# **Martin Place, Over Station Development, North Site**

## **Architectural Design Statement**

**22/04/22**

## Architects Statement

**Approved SSDA Level 20 Plan**  
Typical example floor

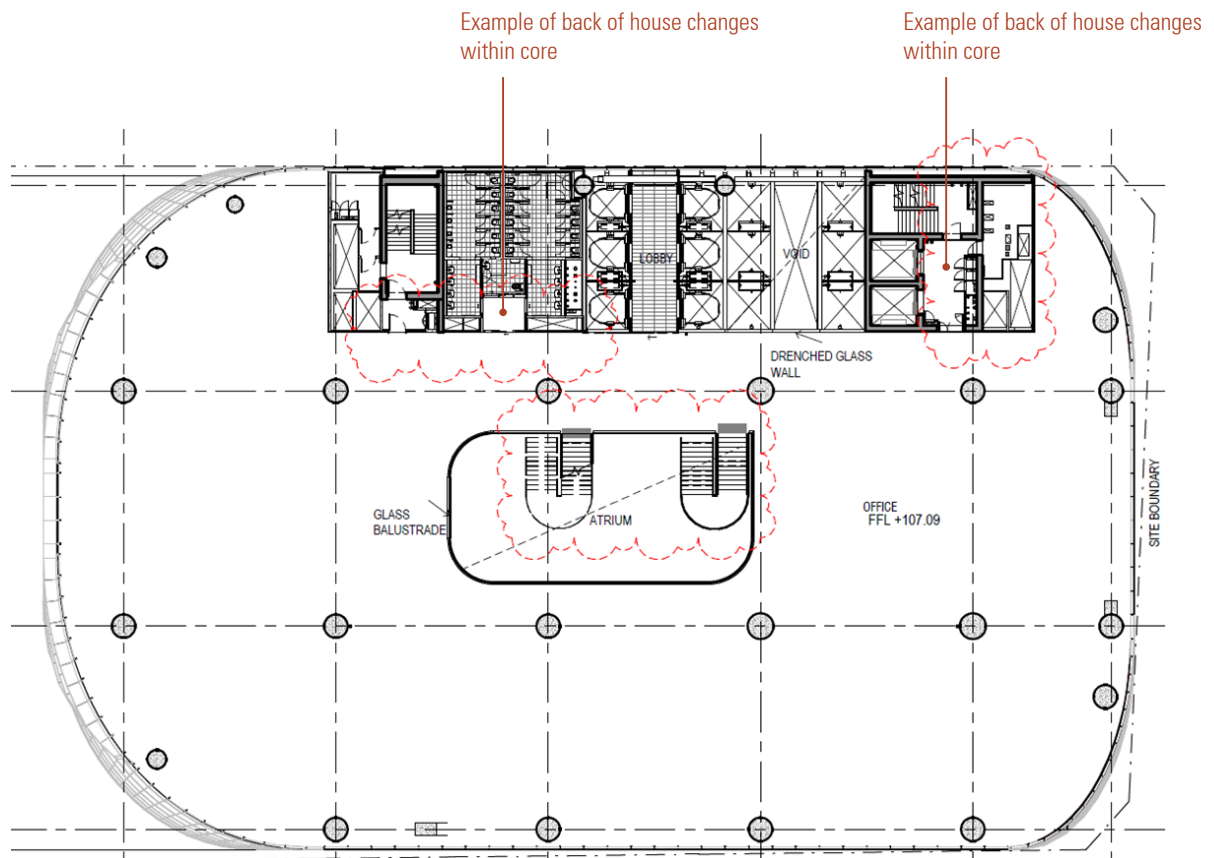
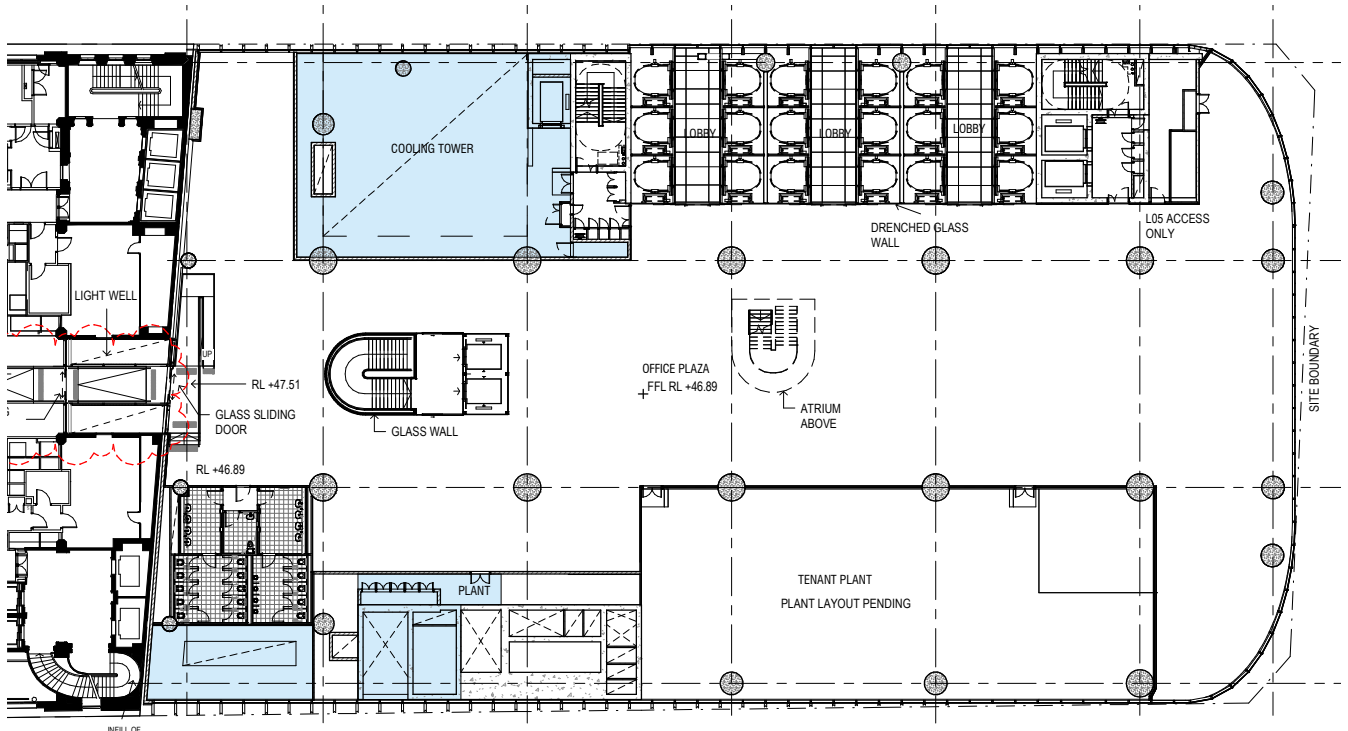
- Minor changes to cupboard doors and internal walls related to back of house amenities, goods lift lobbies and fire stair lobbies;
- Minor changes to the high rise fire stair setouts;
- Minor adjustments to the plant areas on Level 28, Lower Roof and Upper Roof; and
- Relocation of tenant plant previously approved on Level 5 to Level 6.

**Proposed Level 5 Plan**

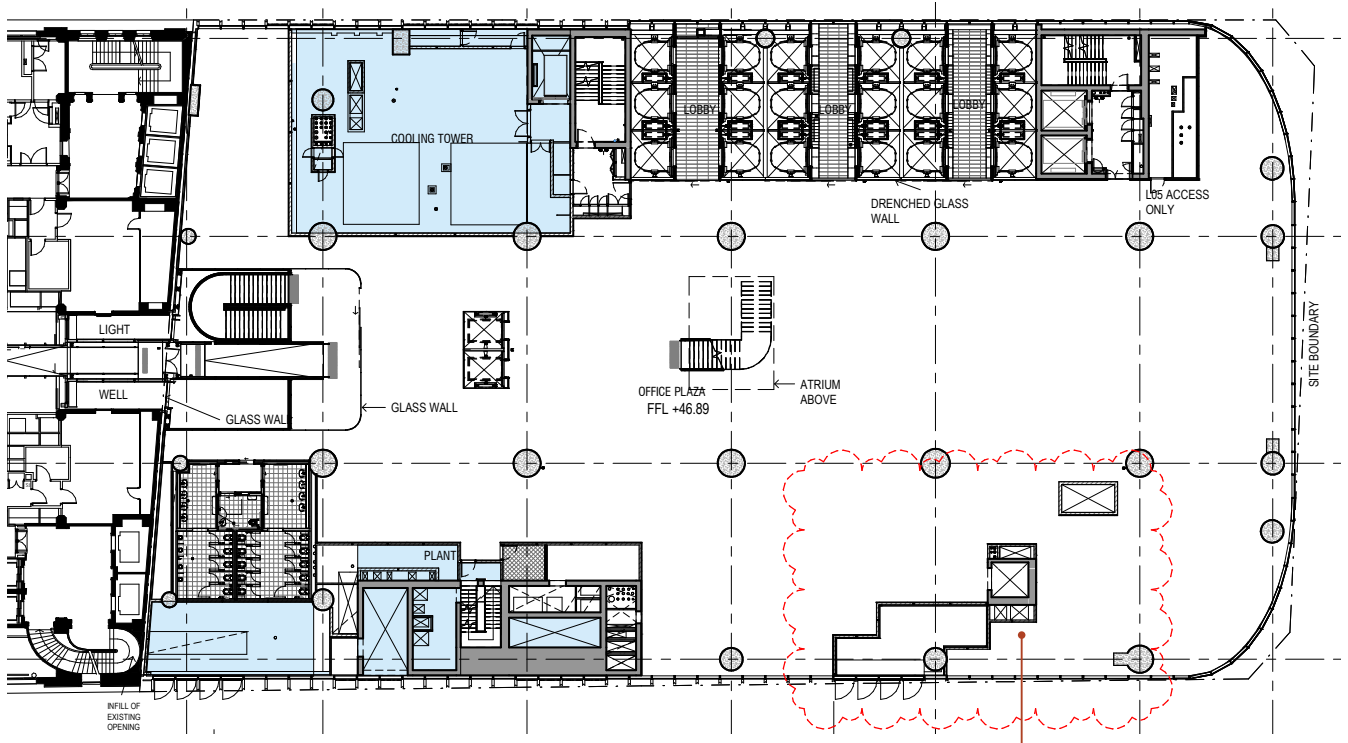
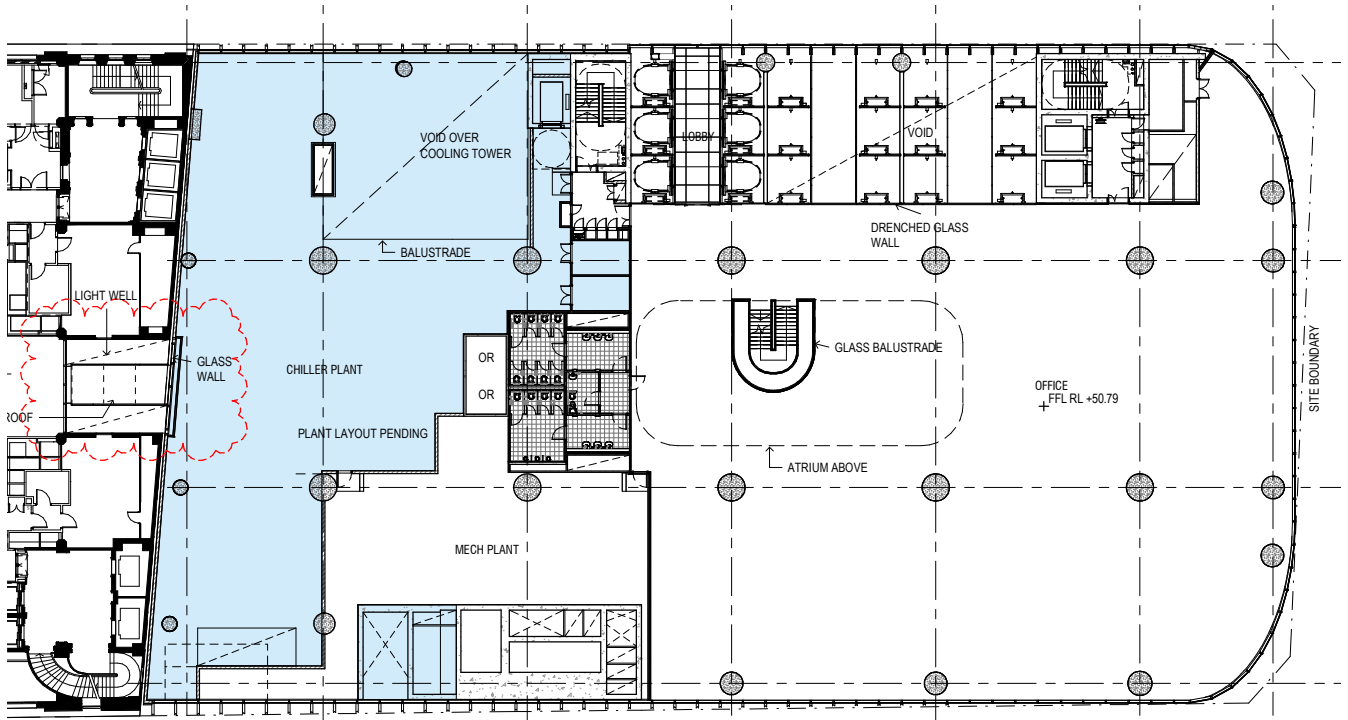
Revised plant elements

**Proposed Level 6 Plan**

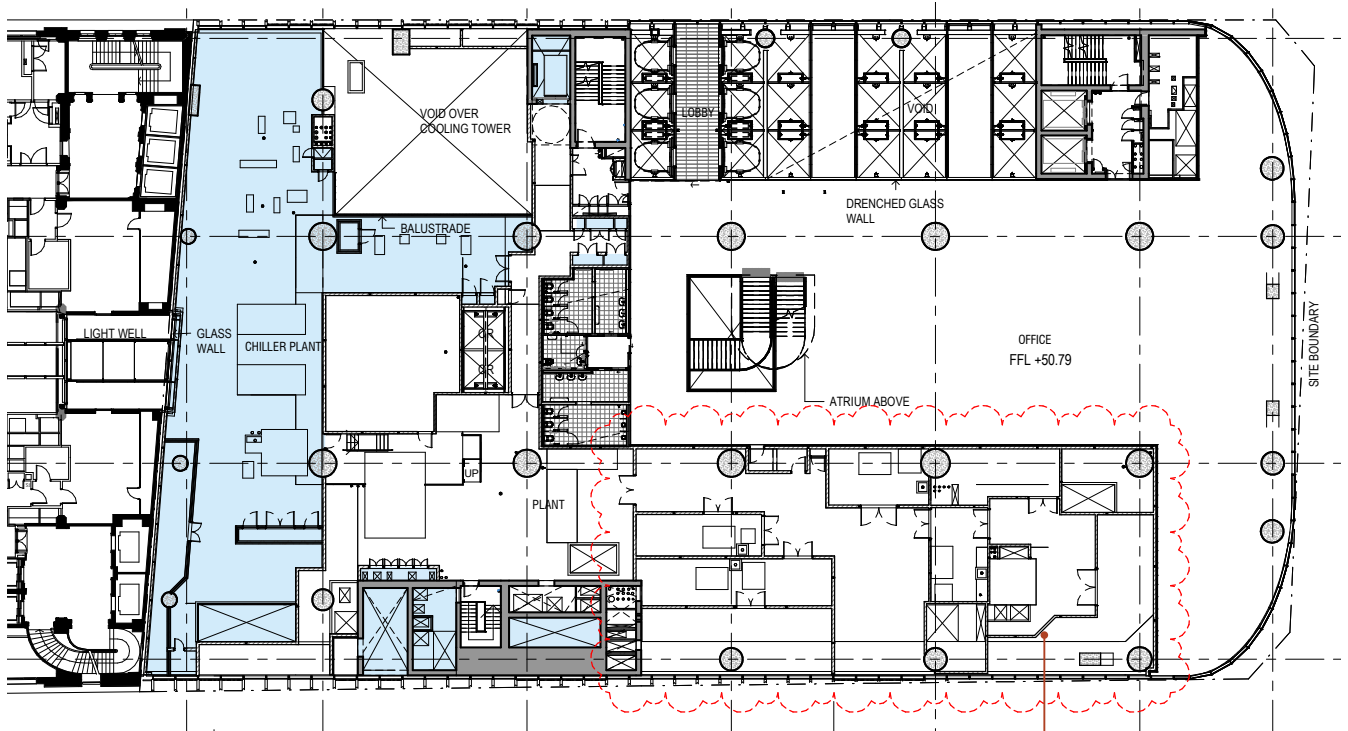
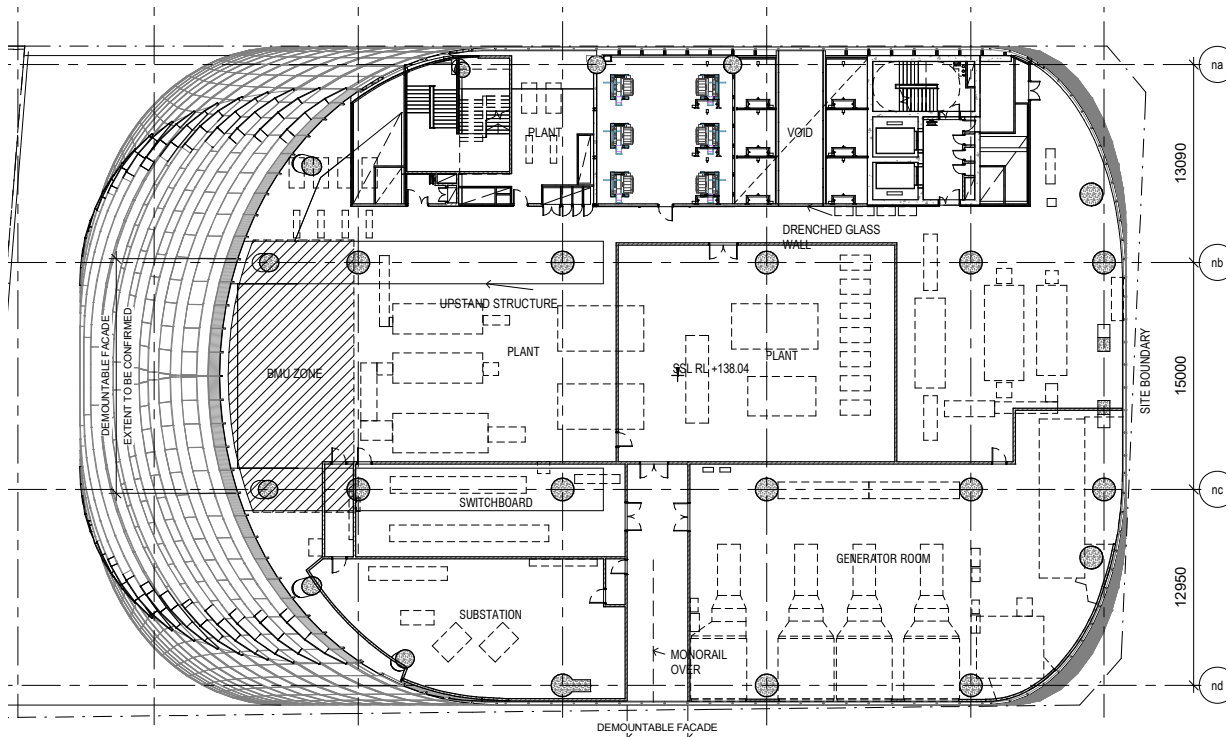
Plant elements relocated from Level 5

Proposed Level 28 Plan

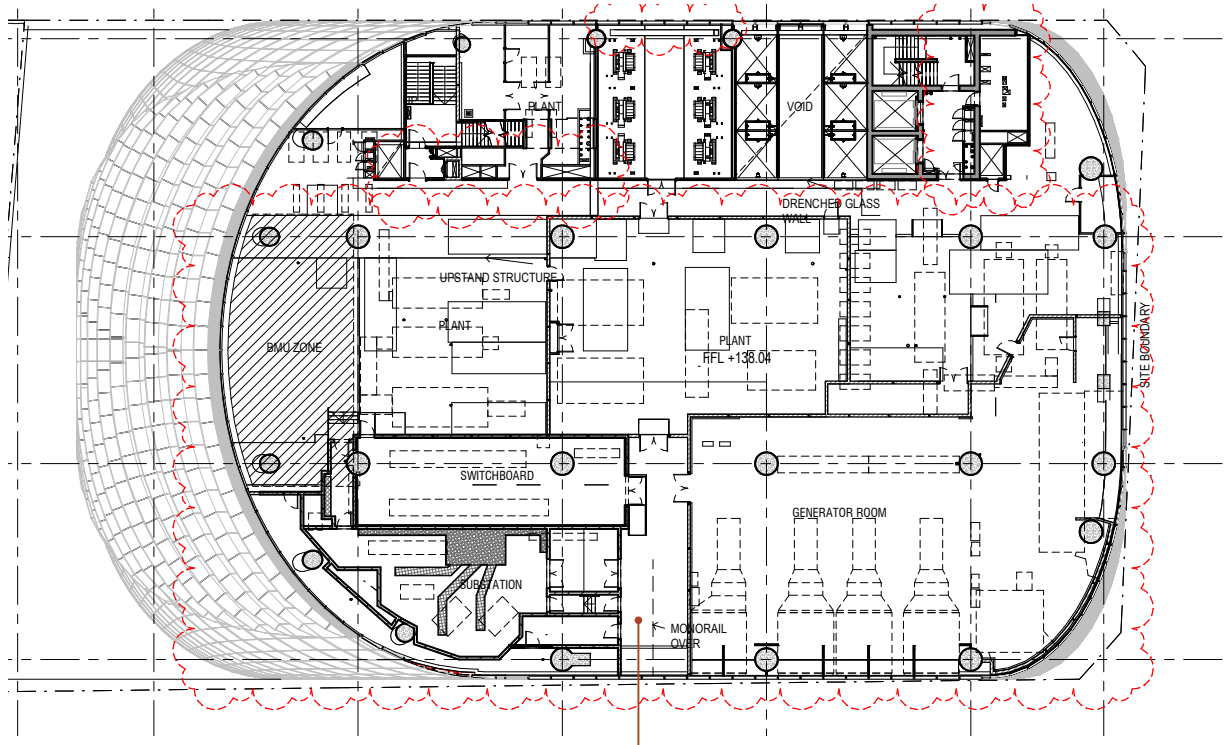
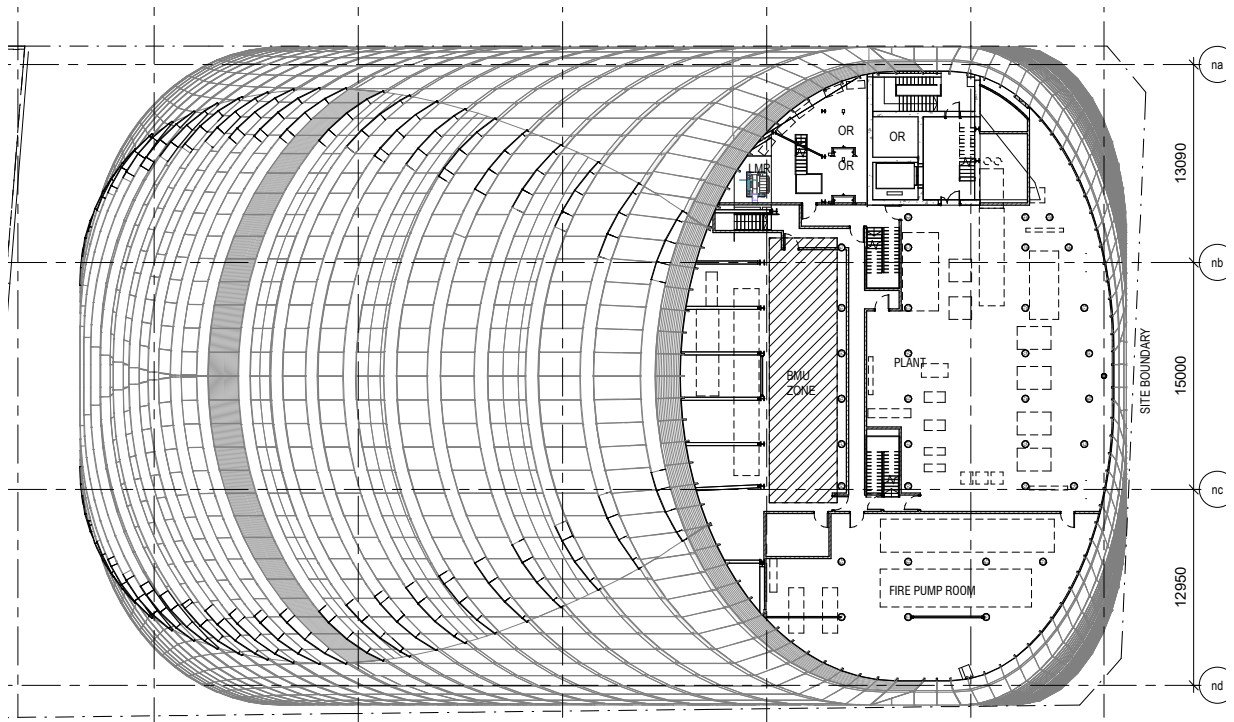
Revised plant arrangement

**Proposed Lower Roof Plan**

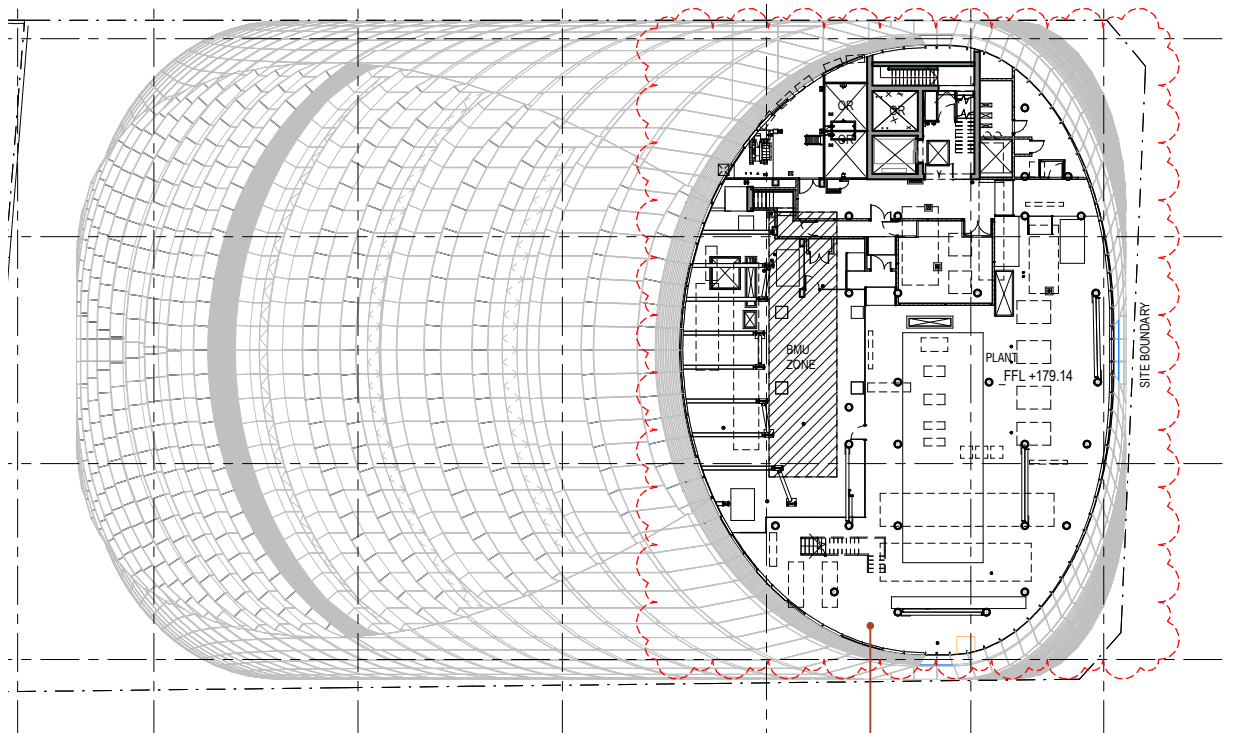
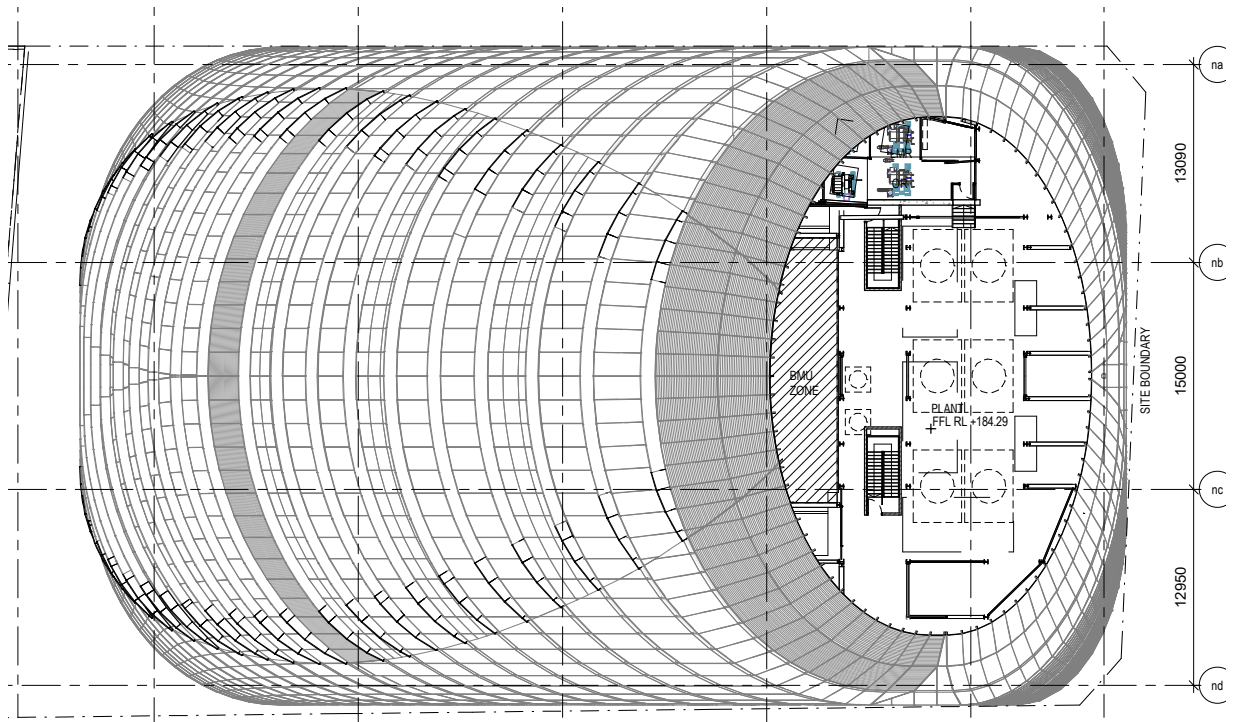
Revised plant arrangement

**Proposed Upper Roof Plan**

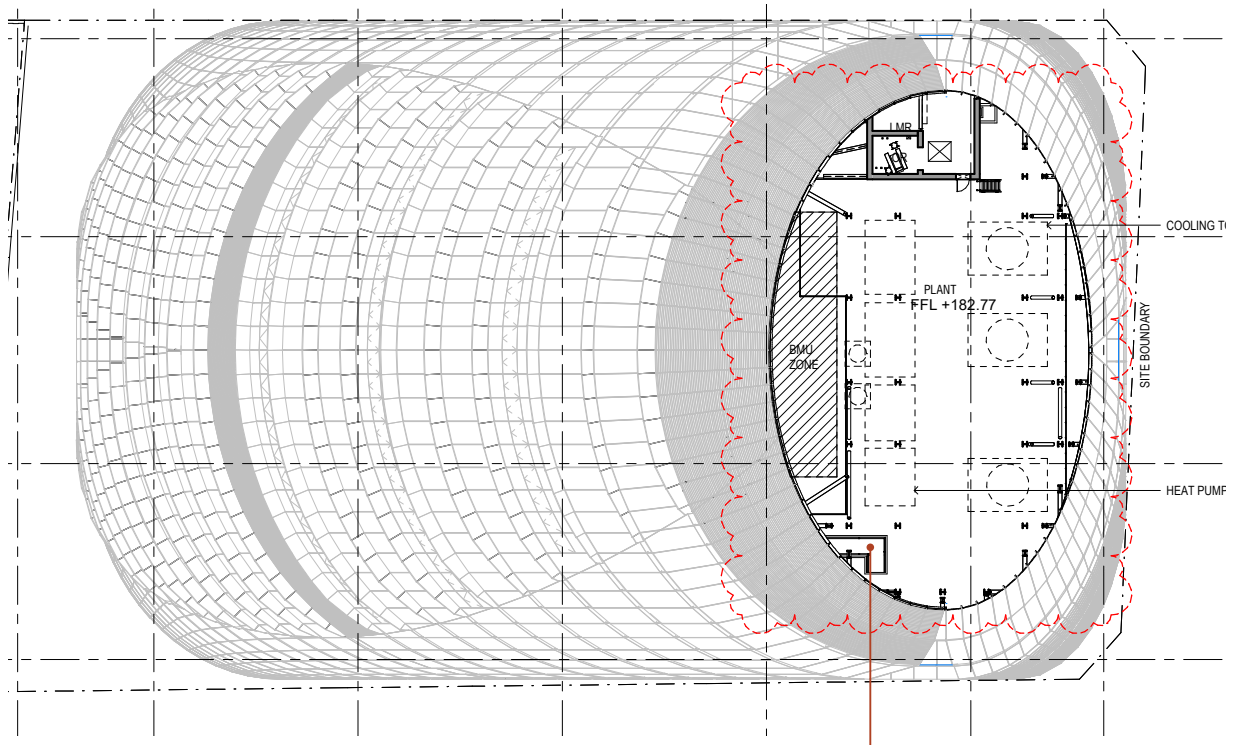
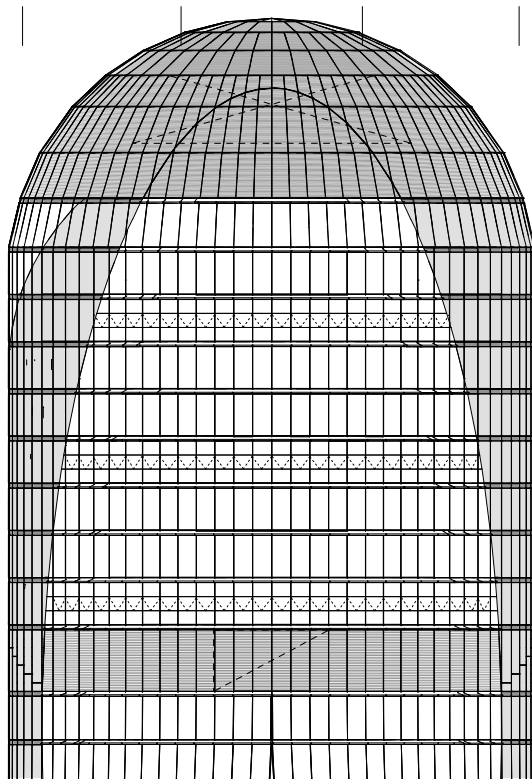
Revised plant arrangement
